Subject: NRC Requests for Additional Information Related to the Audit of the Economic Simplified Boiling Water Reactor (ESBWR) Steam Dryer Design Methodology Supporting Chapter 3 of the ESBWR Design Control Document – Second Draft Response for RAI 3.9-277

Draft Response for RAI 3.9-277

NRC RAI 3.9-277

Figure 1 - Full penetration groove welded butt joint

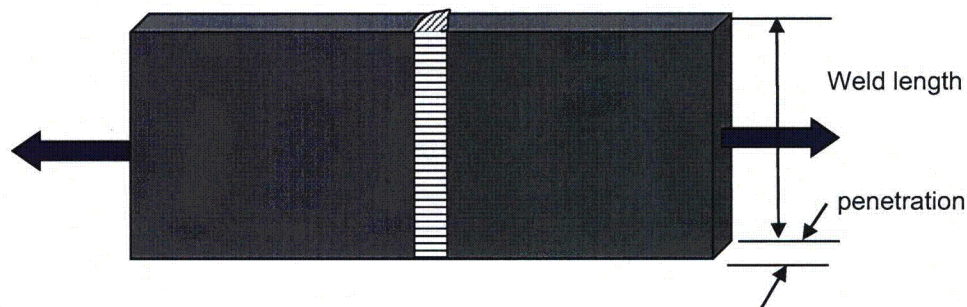
GEH is requested to discuss the use of specific types of welds in the ESBWR steam dryer and the justification for fatigue and quality factors for each weld type. In addition, GEH is requested to discuss the [[]] in the ESBWR steam dryer as described in NEDE 33313P, Rev 2. During the audit, the staff asked GEH to address the [[]] in the ESBWR steam dryer design, and how the [[]] will be conducted. At the audit, GEH made a definitive statement that the ESBWR steam dryer design [[]]. The staff noted that this is inconsistent with NEDE 33313P, Rev 2. Please provide clarification if [[]] in the ESBWR steam dryer.

]]. The effective weld area is based on the effective throat or joint penetration times the effective weld length. For full penetration, the joint penetration is the thickness of the thinner member being joined (see figure 1).
